Access Compliance Report

Public Rights-of-Way

(Curb Ramps)

Intersection ID: 13448	Main Street: MERRIMAN_AV	Cross Street: WEST_BV	Location: NE
ADA ID: EED749C74AF5	Ramp Type: PerpDiag	Initial Pass/Fail: Fail	Overall Compliance: No
Severity Score: 12.5			
Codes/Mitigation Info/Possible Solution		Field Measurements/Component Compliance

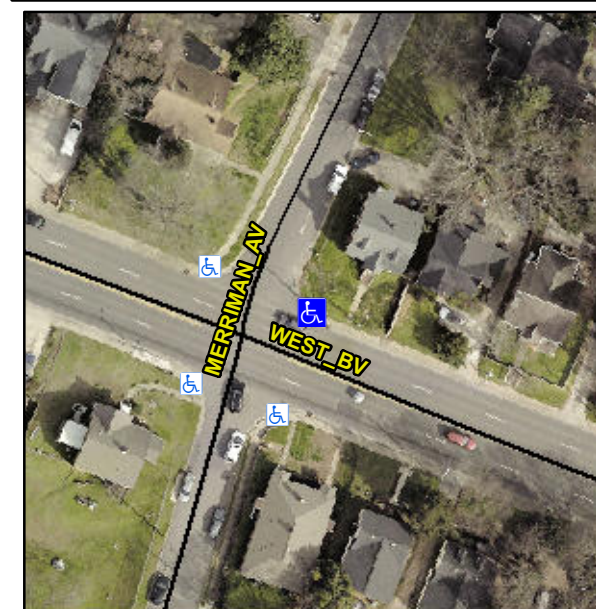
Not Found, R304.5.3

Compliance	Description	Data	Compliance	Description	Data
N/A	Ramp Length (in)	44.0	Yes	Ramp Slope (%)	7.4
Yes	Ramp Width (in)	48.0	No	Ramp XSlope (%)	5.5
N/A	Flare Type LT	N/A	N/A	Flare Type RT	N/A
N/A	Flare Slope LT (%)	N/A	N/A	Flare Slope RT (%)	N/A
N/A	Flare Traversable LT?	N/A	N/A	Flare Traversable RT?	N/A
N/A	Landing Length (in)	N/A	N/A	DWS Provided?	N/A
N/A	Landing Width (in)	N/A	N/A	DWS Contrast?	N/A
N/A	Landing Slope (%)	N/A	N/A	DWS Length (in)	N/A
N/A	Landing X Slope (%)	N/A	N/A	DWS Full Width?	N/A
N/A	Landing Curb? (Y/N)	N/A	N/A	DWS Offset (in)	N/A
N/A	Shared Landing?	N/A			
N/A	Gutter Ponding?	N/A	N/A	Gutter Slope (%)	N/A
N/A	Gutter Lip Ht (in)	N/A	N/A	Gutter X Slope (%)	N/A
N/A	Painted X Walk1?	No	N/A	Painted X Walk2?	No
	X Walk 1 Direction	To NW		X Walk 2 Direction	To SW
N/A	X Walk 1 Width (in)	N/A	N/A	X Walk 2 Width (in)	N/A
	X Walk 1 Slope (%)	5.5		X Walk 2 Slope (%)	2.2
	X Walk 1 X Slope (%)	3.0		X Walk 2 X Slope (%)	4.4

Remove & Replace Curb Ramp With Two New Directional Ramps or Equivalent.
